Access Compliance Report

Public Rights-of-Way

(Curb Ramps)

Intersection ID: 46200	Main Street: LOROPETALUM_RD	Cross Street: FERNSPRAY_RD	Location: NW
ADA ID: 0C4D7DED6E6B	Ramp Type: PerpDiag	Initial Pass/Fail: Fail	Overall Compliance: No
Severity Score: 10			
Codes/Mitigation Info/Possible Solution		Field Measurements/Component Compliance

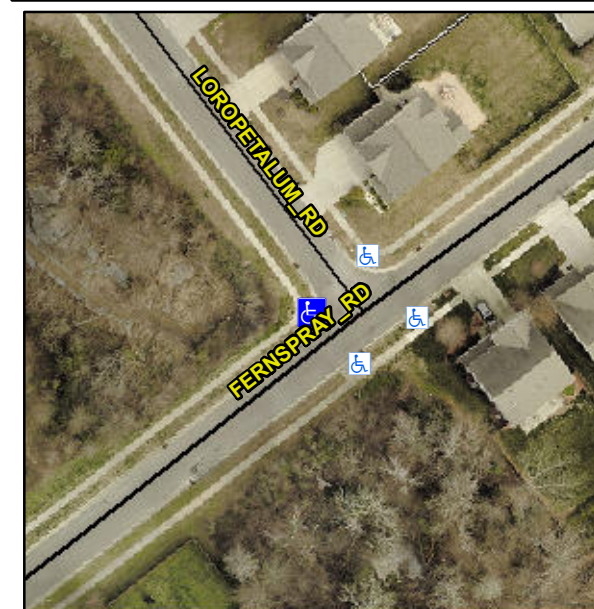
Not Found, R304.5.1, R304.5.3

Compliance	Description	Data	Compliance	Description	Data
N/A	Ramp Length (in)	74.0	Yes	Ramp Slope (%)	6.6
No	Ramp Width (in)	47.0	No	Ramp XSlope (%)	2.2
N/A	Flare Type LT	N/A	N/A	Flare Type RT	N/A
N/A	Flare Slope LT (%)	N/A	N/A	Flare Slope RT (%)	N/A
N/A	Flare Traversable LT?	N/A	N/A	Flare Traversable RT?	N/A
N/A	Landing Length (in)	N/A	N/A	DWS Provided?	N/A
N/A	Landing Width (in)	N/A	N/A	DWS Contrast?	N/A
N/A	Landing Slope (%)	N/A	N/A	DWS Length (in)	N/A
N/A	Landing X Slope (%)	N/A	N/A	DWS Full Width?	N/A
N/A	Landing Curb? (Y/N)	N/A	N/A	DWS Offset (in)	N/A
N/A	Shared Landing?	N/A			
N/A	Gutter Ponding?	N/A	N/A	Gutter Slope (%)	N/A
N/A	Gutter Lip Ht (in)	1.0	N/A	Gutter X Slope (%)	N/A
N/A	Painted X Walk1?	No	N/A	Painted X Walk2?	No
	X Walk 1 Direction	To SE		X Walk 2 Direction	To NE
N/A	X Walk 1 Width (in)	N/A	N/A	X Walk 2 Width (in)	N/A
	X Walk 1 Slope (%)	0.7		X Walk 2 Slope (%)	0.5
	X Walk 1 X Slope (%)	3.4		X Walk 2 X Slope (%)	2.4

Remove & Replace Curb Ramp With Two New Directional Ramps or Equivalent.
